ACAD The copyright of this drawing is reserved by HELLERMANN TYTON. It is issued on condition that it is not reproduced, copied or disclosed to a third party, either wholly or in part, without the consent of HELLERMANN TYTON.	Drawn MANDY ONG 10 Oct 2007	Approved. EDWARD TAN 10 Oct 2007	Scale: 1 : 1 Reference:
	HellermannTyton 545, Yishun Industrial Park A Yishun Avenue 7 Singapore 768741 Tel: (+65) 6852 8585 Fax: (+65) 6756 6798		Title T50RFT6 Drawing-No [SG07030-05] 93-0077-007-CSH Format A4 Sheet 1 of 1

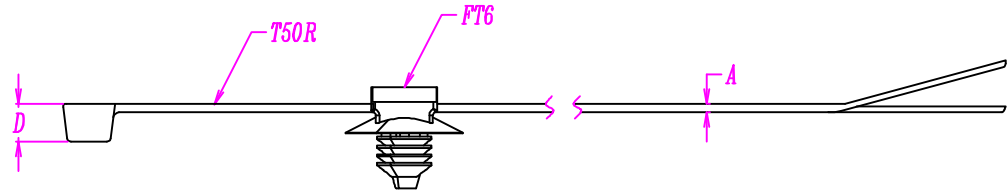
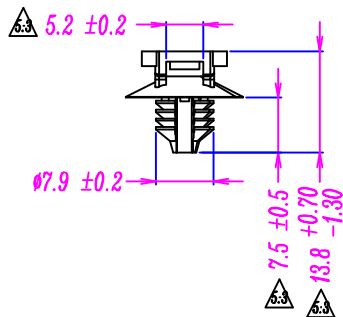
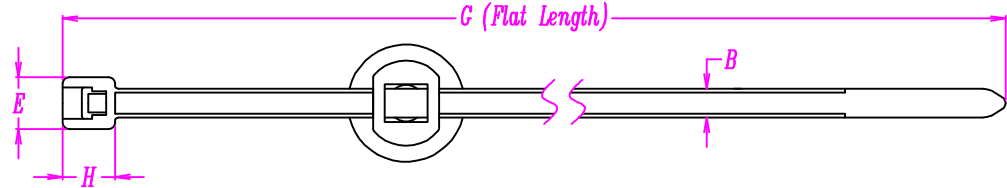
6.3	(Requested by Amanda Harris to update drawing dimension and tolerance according to drawing no. NT14.1164) 1. Update hole size from $\phi 6.5 \sim \phi 7.0$ to $\phi 6.4 \sim \phi 7.1$ mm 2. Update dimension from 5.0 ± 0.2 to 5.2 ± 0.2 mm 3. Update dimension from 13.5 ± 1.0 to 13.8 ± 0.3 mm 4. Update dimension from 7.2 ± 0.5 to 7.5 ± 0.5 mm	SIMON NG	11-June-19	Edward Tan	11-June-19

Hole Size :
 $\phi 6.4 \sim \phi 7.1$ mm
